Appendix N – Public Consultation

Schedule “C” Class Environmental Assessment for Airport
Road from Braydon Boulevard / Stonecrest Drive to
Countryside Drive

N.2 – Public Information Centre #1 Summary Report

N.3 – Public Information Centre #2 Summary Report

Exhibit 2-3: Attendees left comments indicating their support of the proposed improvements to Airport Road

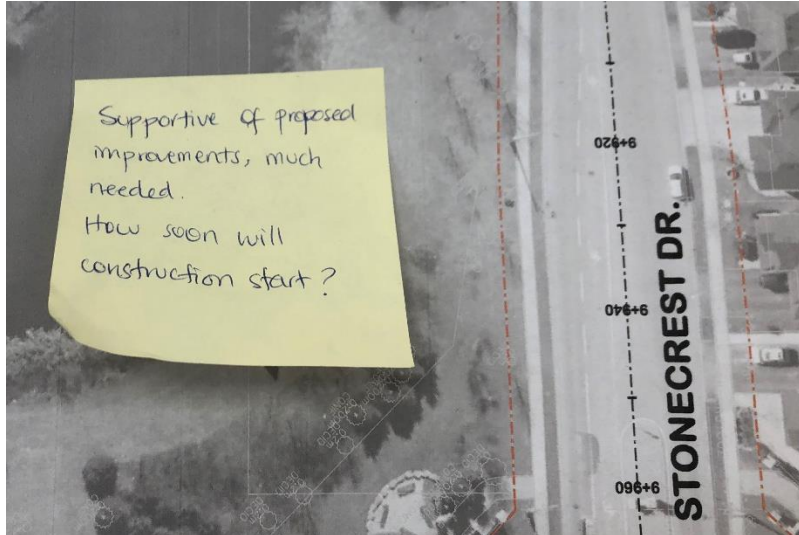
Residents and stakeholders present were supportive of the proposed improvements to Airport Road. Some attendees remarked on the need for improvements along this corridor and inquired about the potential construction start date, per the note shown in **Exhibit 2-3**.

- **Consideration of intersection pedestrian signals (IPS)** at Treeline Boulevard and Eagle Plains Drive to facilitate safe access for pedestrians and transit users.
- **Review the location of the proposed multi-use path (MUP) at the plaza entranceway** south of Countryside Drive to improve visibility and raising the MUP across the entranceway to reduce the speed of vehicles.
- **Confirm that the proposed crosswalks do not overlap** at intersection locations as they should terminate at the curb per AODA requirements.
- **Revise the island on the north leg of the intersection at Airport Road and Countryside Drive** as it is encroaching into the proposed cross-ride.

Based on the input received during the PIC, the project team will confirm the study findings and further refine the preliminary preferred design ahead of filing of the Environmental Study Report.
